UNITED STATES PATENT AND TRADEMARK OFFICE

APPLICATION NO.	FILING DATE	FIRST NAMED INVENTOR	ATTORNEY DOCKET NO.	CONFIRMATION NO.
10/815,990	04/02/2004	Richard Rund	551.0006	7262
25534	7590	04/06/2005	EXAMINER	
CAHN & SAMUELS LLP 2000 P STREET NW SUITE 200 WASHINGTON, DC 20036			VERBITSKY, GAIL KAPLAN	
			ART UNIT	PAPER NUMBER
			2859

Office Action Summary

DETAILED ACTION

attachment # 1 / 03/15/05

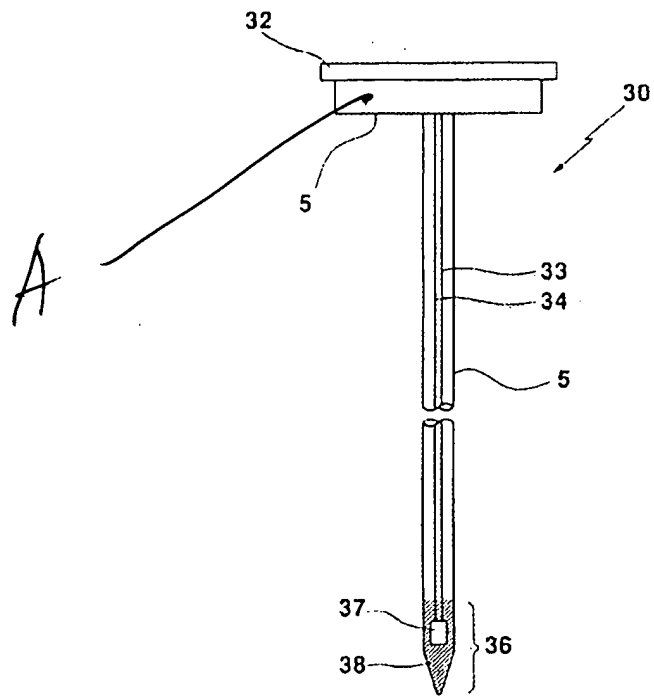
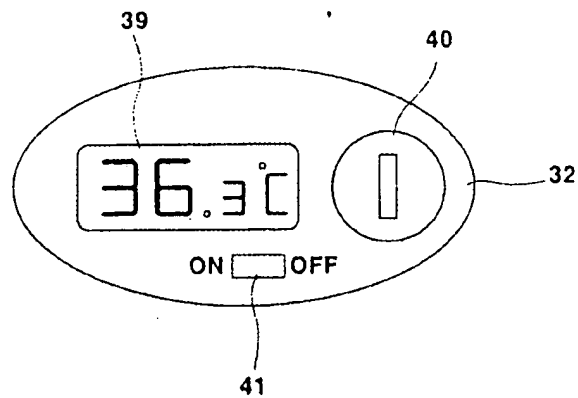
Lee discloses in Figs. 5-6 an electronic digital thermometer comprising a housing having a first portion A and a second portion 32. Although it is not shown in Figs., the fact that the first portion contains a circuit (microprocessor) 42 would imply that the first portion comprises a cavity. The thermometer also comprises a probe portion containing a temperature-sensing element 37. (The numeral A has been added by the Examiner, see attachment #1 to the Office Action).

Lee does not explicitly teach a waterproof seal, that the conversion logic is encapsulated in a low thermal conductivity material, and an insulating member, as stated in claim 1.
